FEBRUARY 8, 2021

SUBJECT: INITIAL COMMENTS LETTER PROJECT NAME: NEIGHBORHOOD STORAGE CENTER #2 OUTDOOR GRASS STORAGE EXPANSION PROJECT #2021010043 APPLICATION: MAJOR SITE PLAN #26062

NSC #2 OUTDOOR GRASS STORAGE EXPANSION - MAJOR SITE PLAN Project #2021010043 #26062 Parcel #31416-000-00 KIMLEY-HORN AND ASSOCIATES

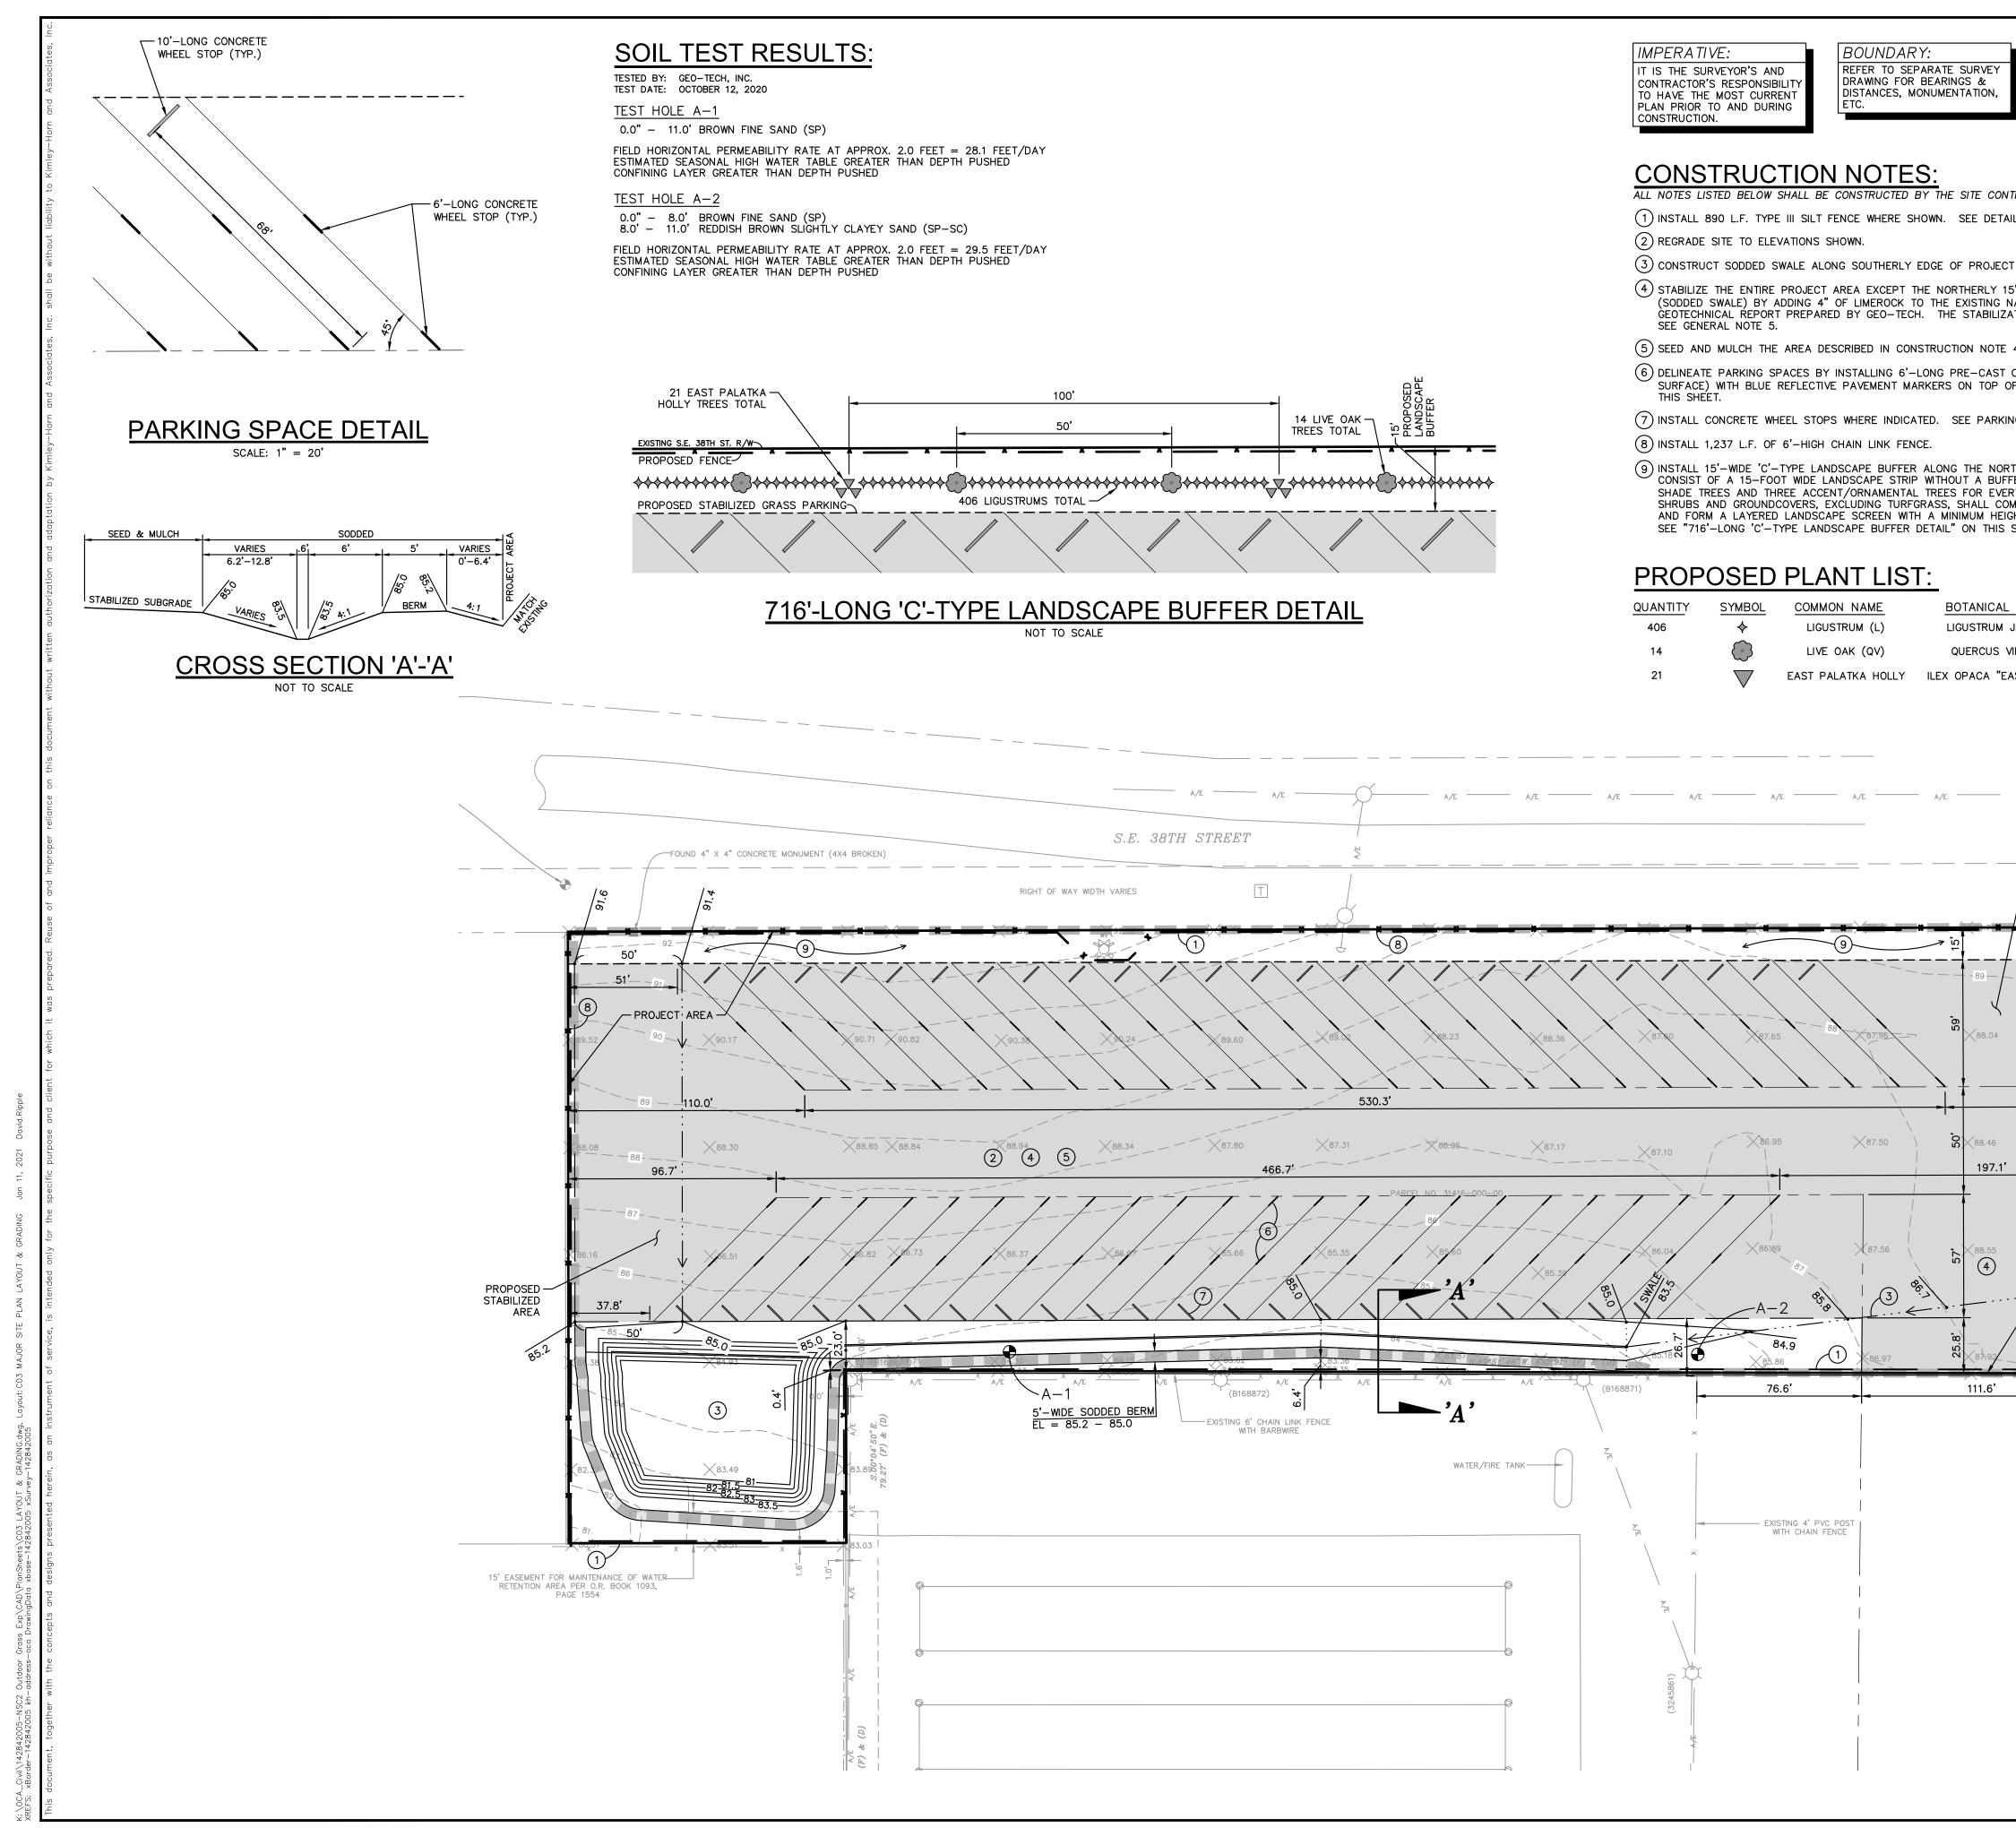
- 8. DEPARTMENT: FRMSH FIRE MARSHAL REVIEW REVIEW ITEM: 6.18.3 - Gated Communities/Properties STATUS OF REVIEW: ENGINEER ACKNOWLEDGED INFO COMMENT REMARKS: The project contains a gate for access to the property. Per Marion County Land Development Code Section 6.18.3 a siren activated gate shall be provided for emergency vehicular access. Please note on the plans the gate will be siren activated. The gate will need to be a minimum of 20 feet in width. The gate on the plans appear to be 20 feet in width. Please note the following on page C03.

- DEPARTMENT: FRMSH FIRE MARSHAL REVIEW REVIEW ITEM: NFPA 1 Chapter 18.2.3 - Fire Dept Access Roads STATUS OF REVIEW: ENGINEER ACKNOWLEDGED INFO COMMENT REMARKS: Plans page C03 show stabilized area on the ends of the parking area. Will need to post no parking fire department access road signage to ensure fire department turn around access is maintained and accessible.

DEPARTMENT: ENGDRN - STORMWATER REVIEW REVIEW ITEM: 6.13.2 A(1)/(2) - Contributing Basins/Tc STATUS OF REVIEW: ENGINEER ACKNOWLEDGED INFO COMMENT REMARKS: Please call out the post-development drainage basin, and label size, on Sheet C03.

- 37. DEPARTMENT: ENGSUR SURVEY REVIEW REVIEW ITEM: 2.12.11 - Provide an aerial map of the site with a layout of the development STATUS OF REVIEW: ENGINEER WILL COMPLY REMARKS: Please overlay sheet C03 onto an aerial.
